FIELD CHANGE NOTICE

CMI-41

Waveform Supervisor

DESCRIPTION	SCSI INTERFACE	DRAWING-NO	CM1-41 rev 1

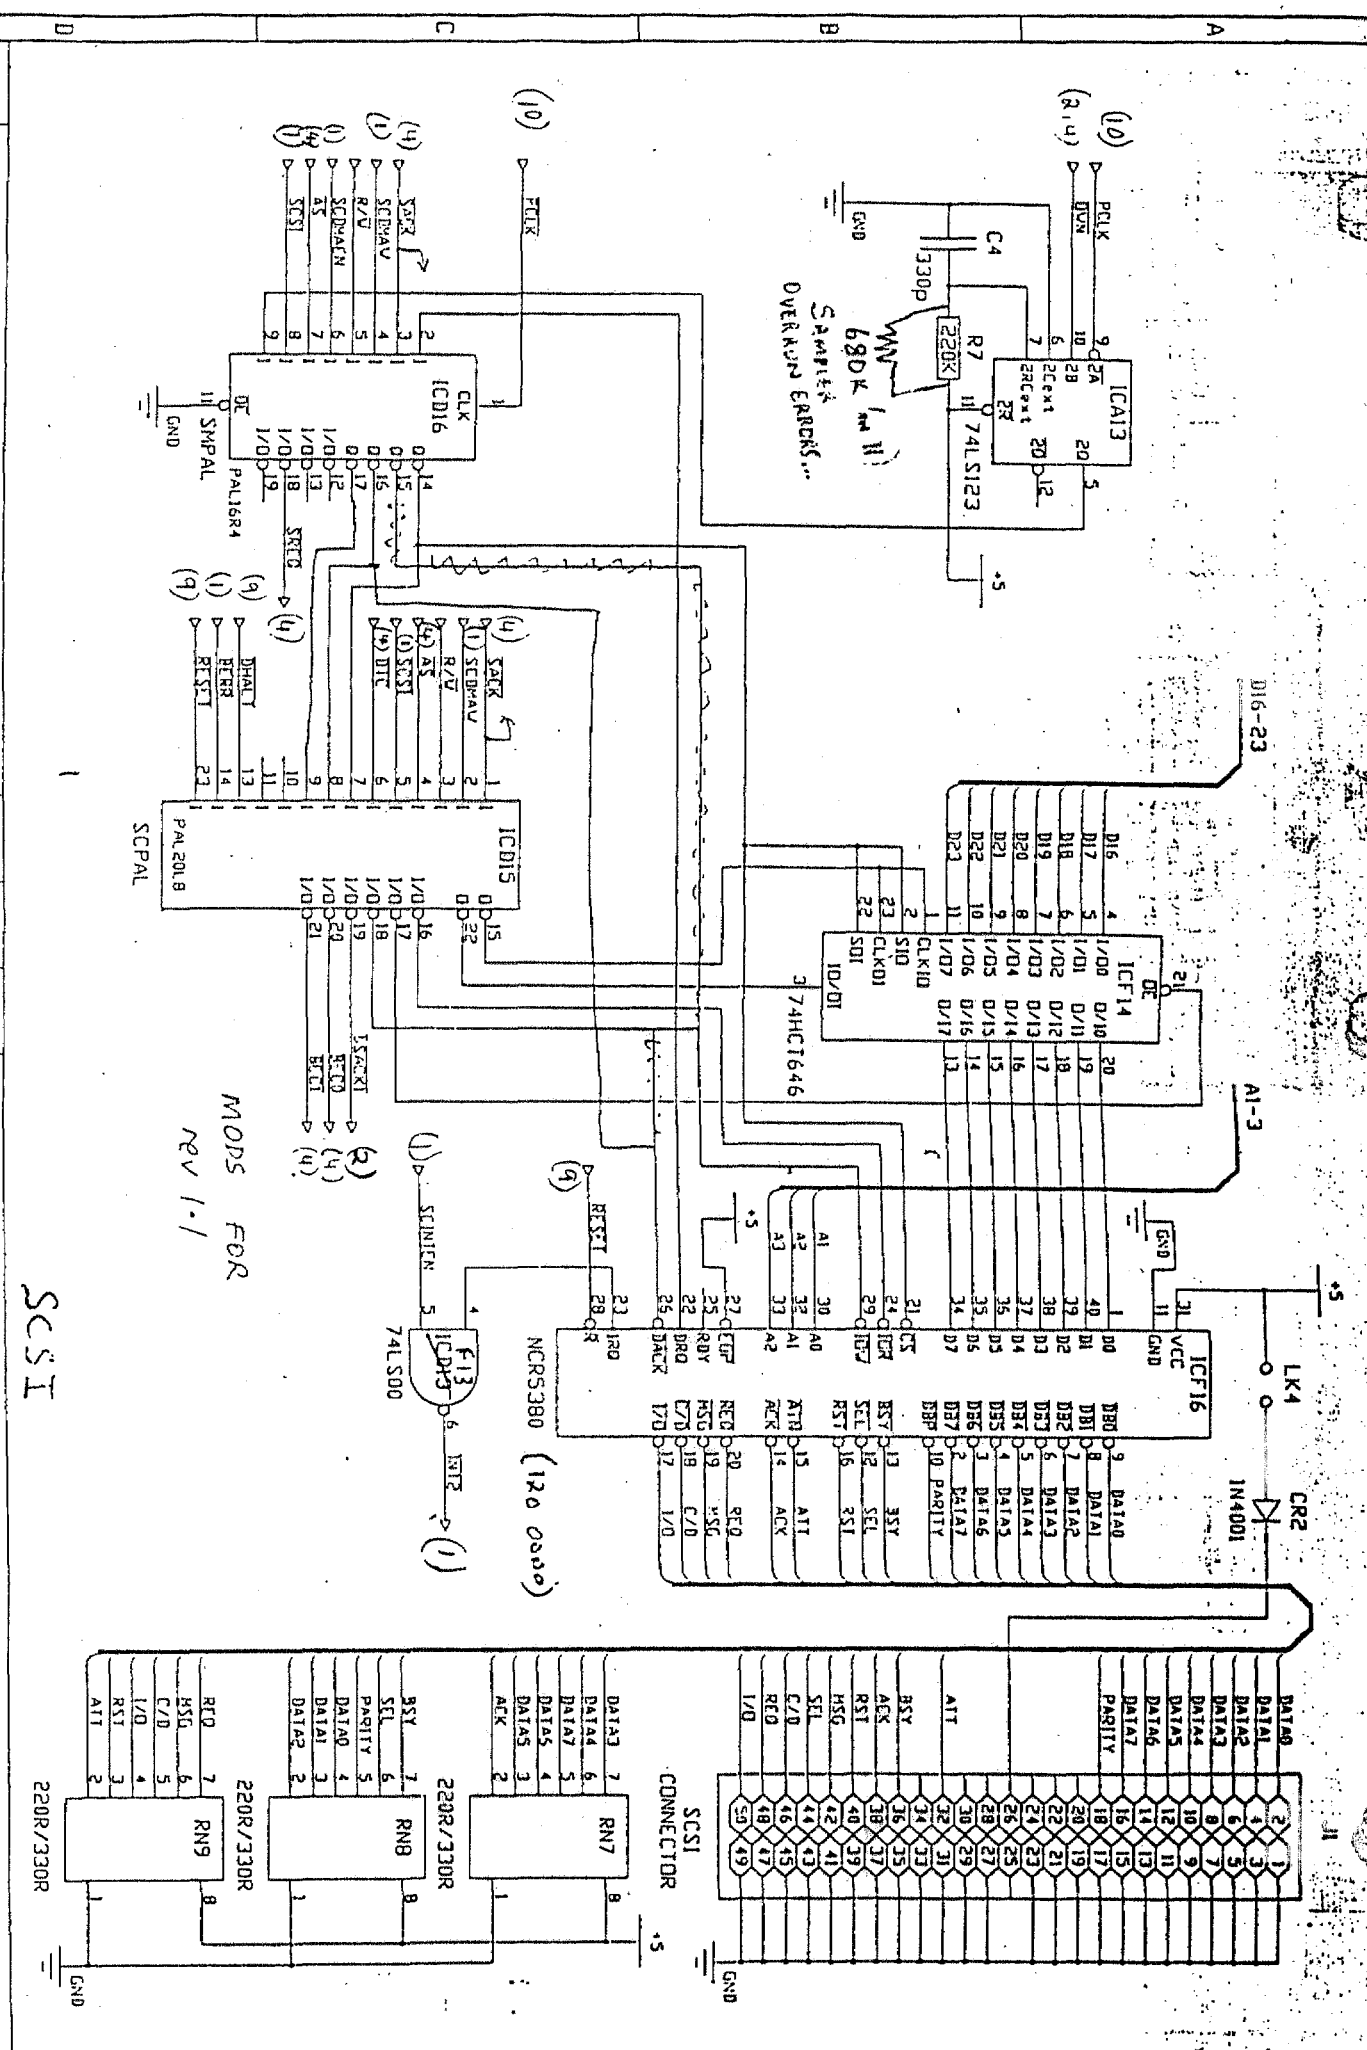
Inaccurate Detection of Channel Card slices

The *TSTAKEN signal is a wire-or signal terminated at the Waveform Supervisor. Currently, *TSTAKEN is terminated at 2.5V. This has been found to provide inadequate noise immunity. To fix the problem, *TSTAKEN is now terminated at 4V.

Replace R4 (820R) with 120R.

** TO BE DONE IN CONJUNCTION WITH FCN 73 **

FCN 73 on CMI31 Channel card, changing Ic 74ls03 to 7438 supports the higher current.

DMA CONTROLLER AND DEMULTIPLEXING

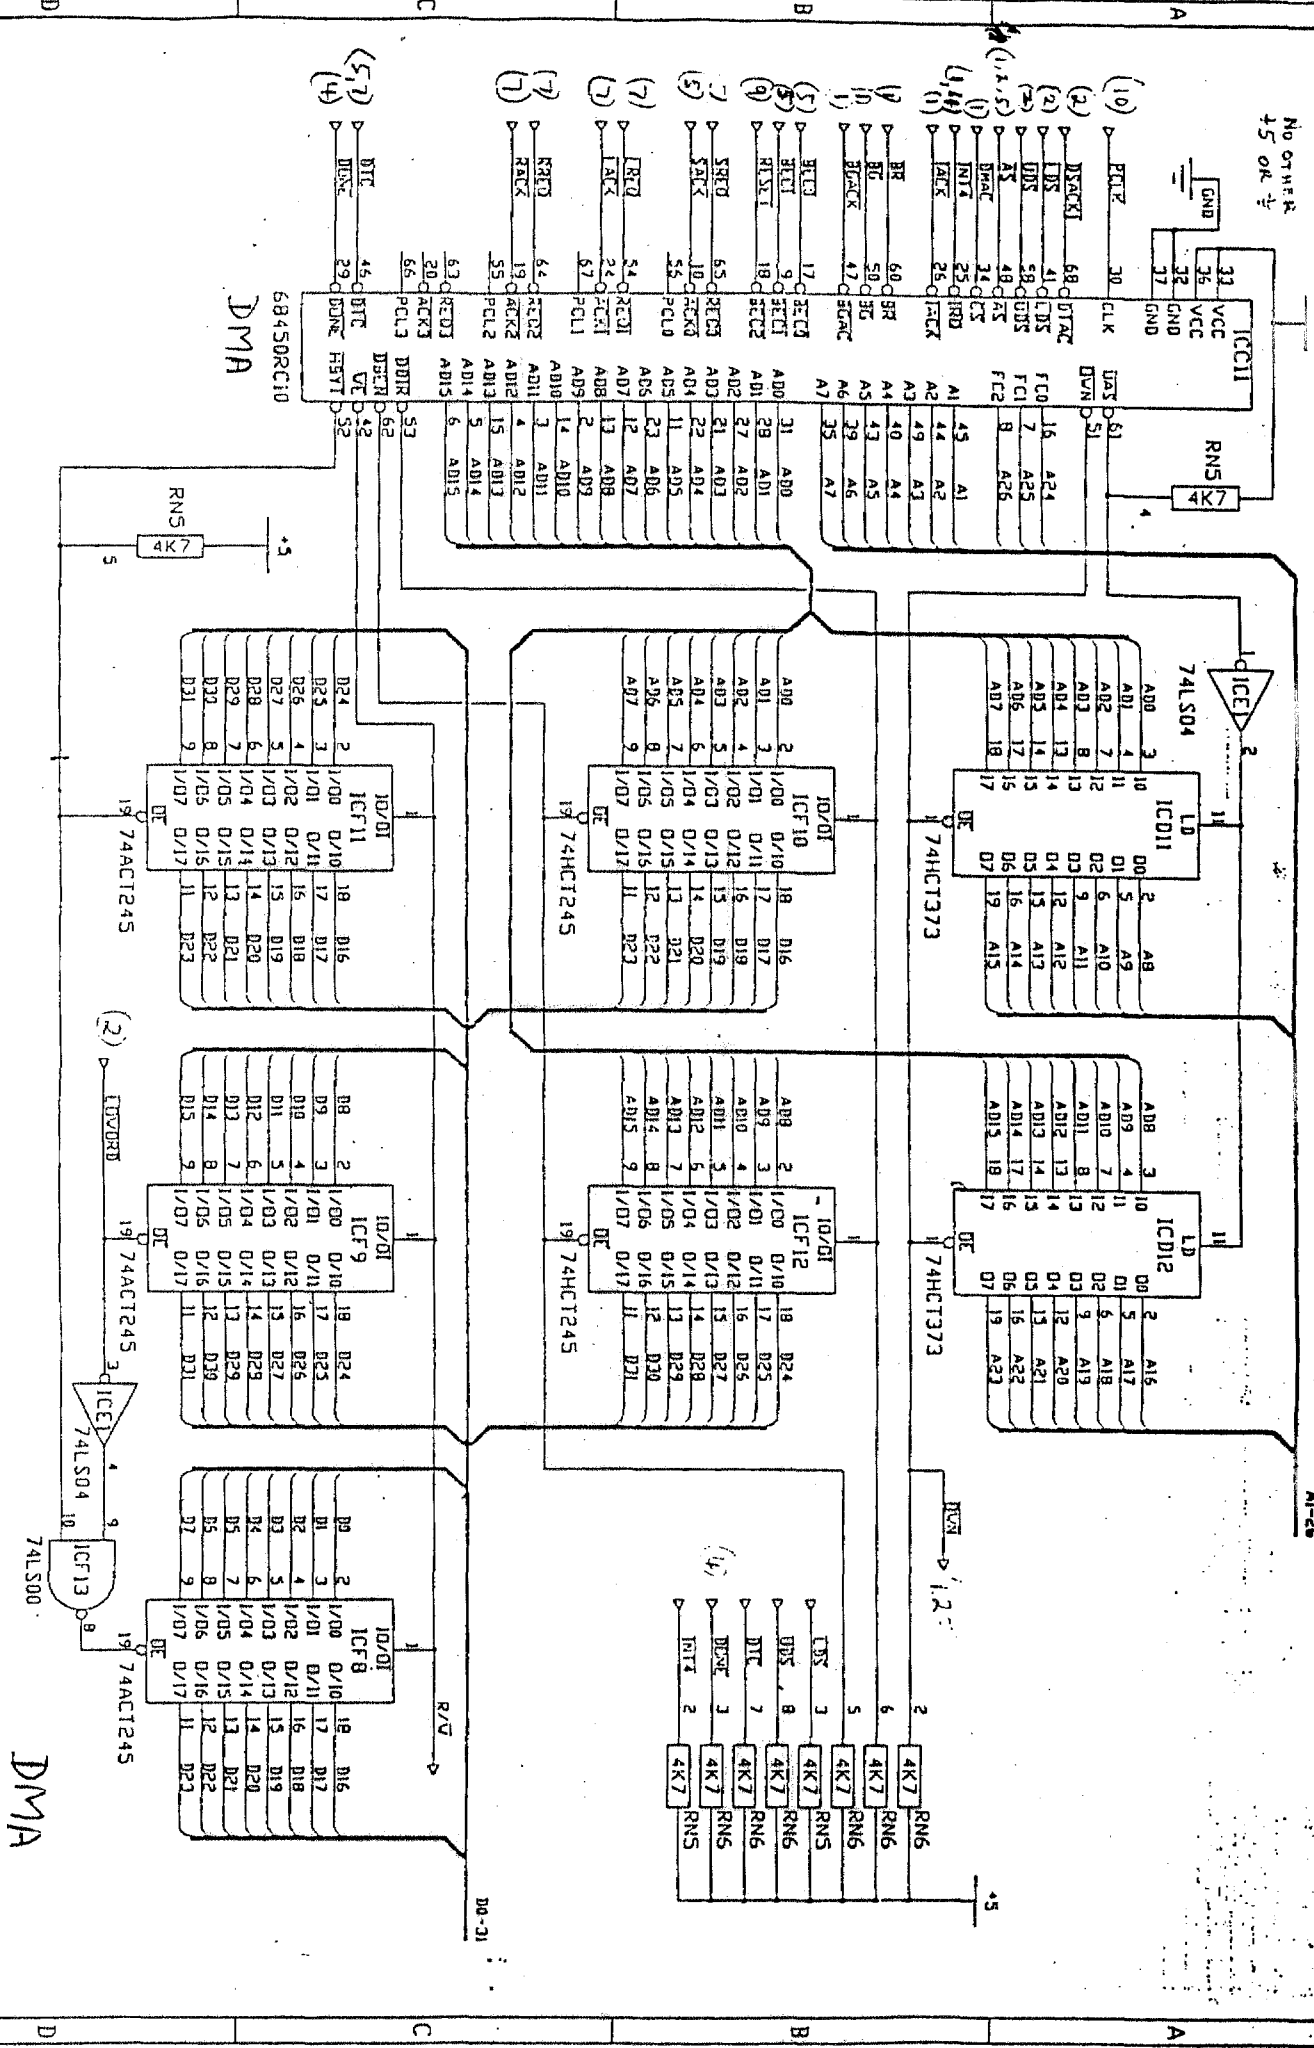
Corruption during Waveform Memory Refresh

Waveform memory corrupted during refresh cycles as a result of glitches on *WREF signal. The solution is to buffer the *WREF signal with a 74HCT244 buffer; rather than drive the signal directly from WBPAL.

Cut track to edge connector pin 71A at the edge connector on wiring side.
Connect ICB16 (WBPAL) pin 16 to ICB2 (74HCT244) pin 11.
Connect ICB2 (74HCT244) pin 9 to edge connector pin 71A.

DYNAMIC RAM ARRAY

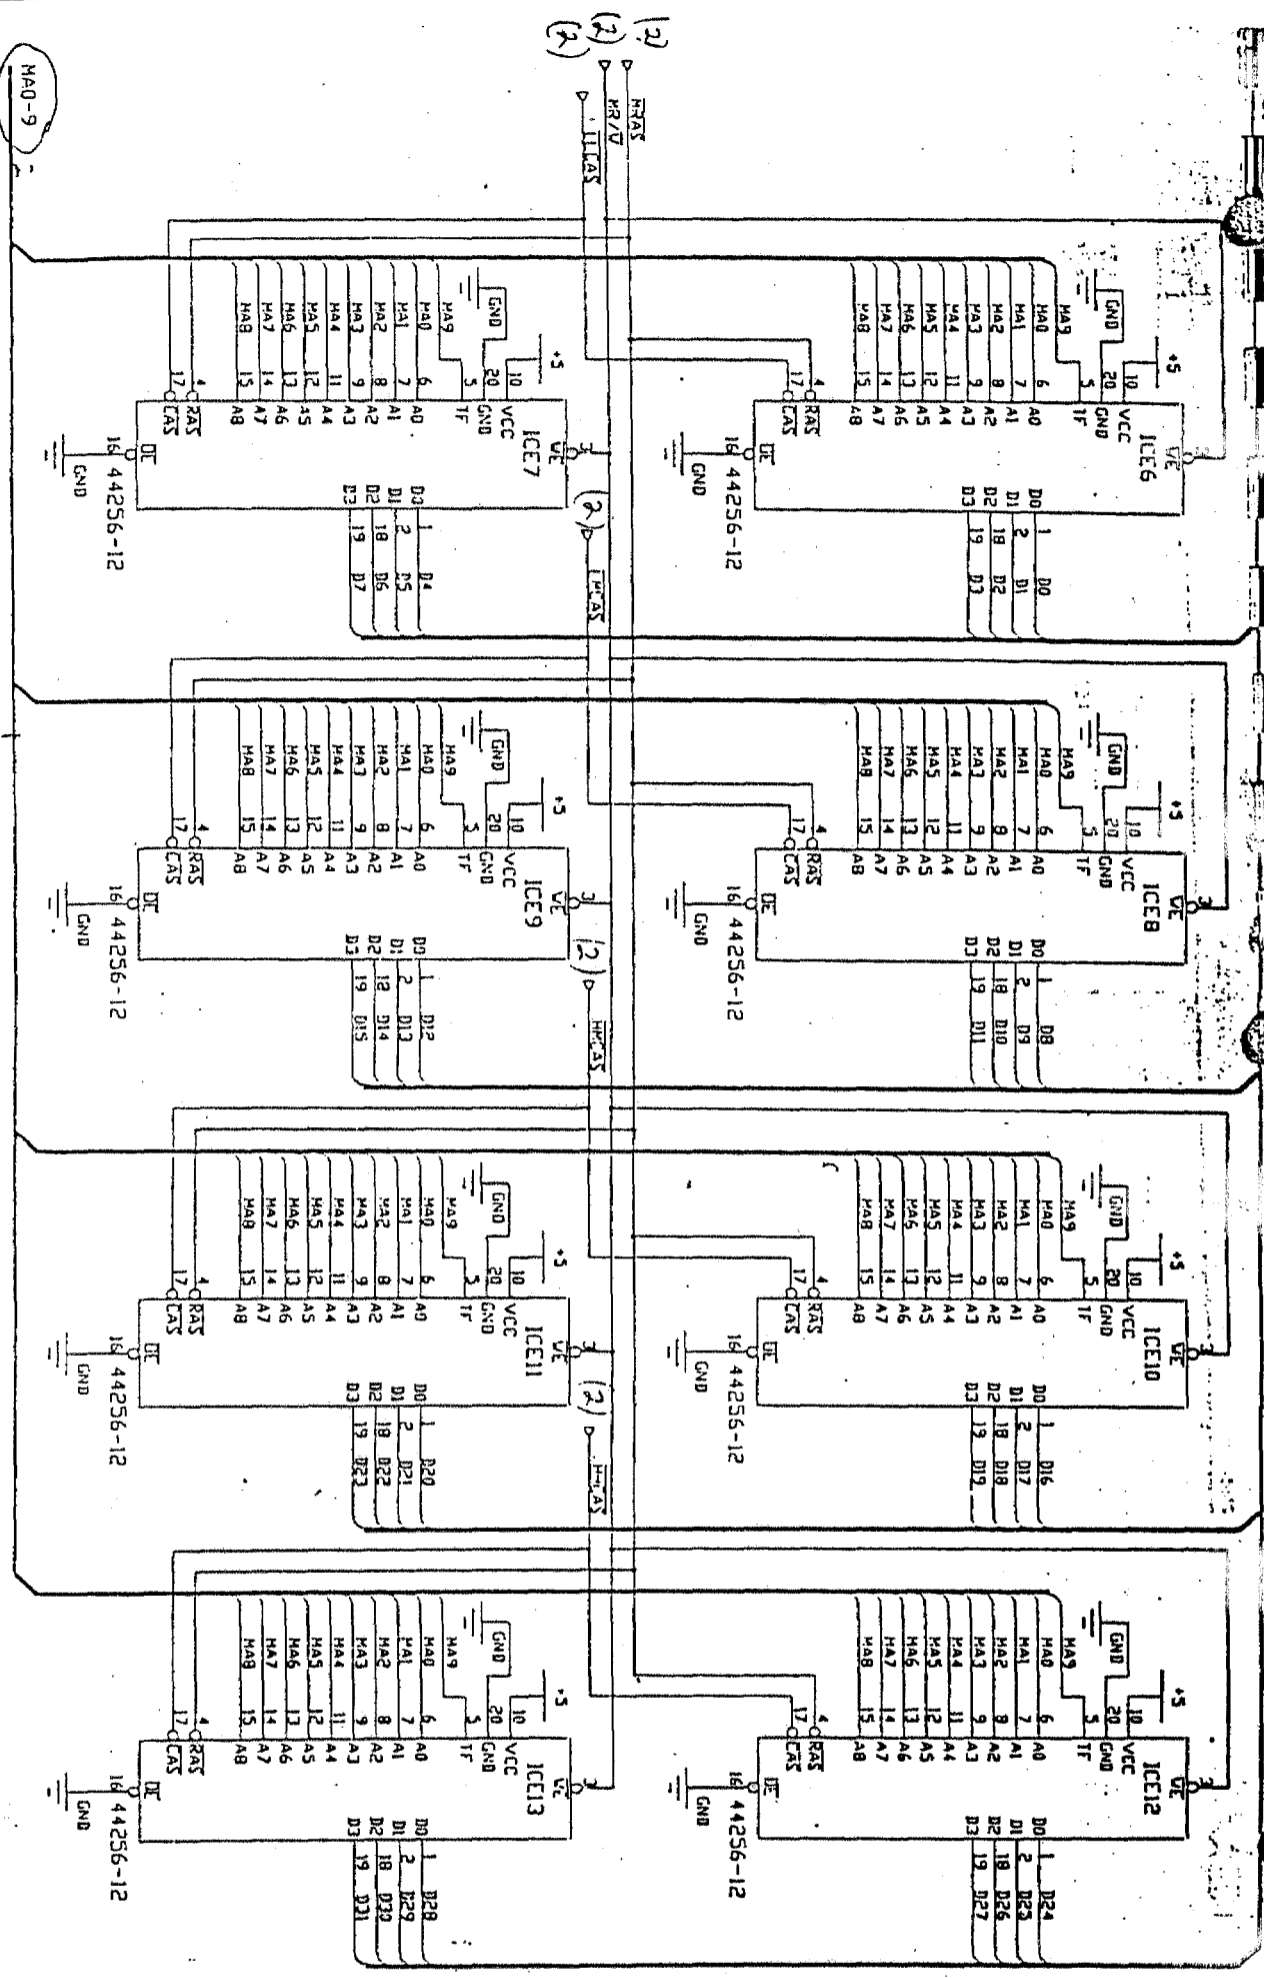
This FCN is required when Rev 10 software is installed.
It is NOT necessary for Rev 9 and below.

1M x 4bit DRAMs (4M DRAMs) require the *WE (write enable) to remain high during CAS-before-RAS refresh cycles. The 256K x 4bit DRAMs (1M DRAMs) considered the *WE signal as DONT CARE during refresh.

Replace DRPAL with DRGAL2

Cut component side track from ICB2/18 (74HCT244) to the plate-thru between ICC1/10 (74HCT240) and the SPARE socket pin 1.

Connect ICB2/18 (74HCT244) to DRGAL2/8.

Connect RN3/8 (33R at D5) to DRGAL2/14.

Replace current Ram with 1M x 4bit DRAMs

LK3 located at D6 - Remove the wire linking pins 1&2. Add a wire link between 2&3.
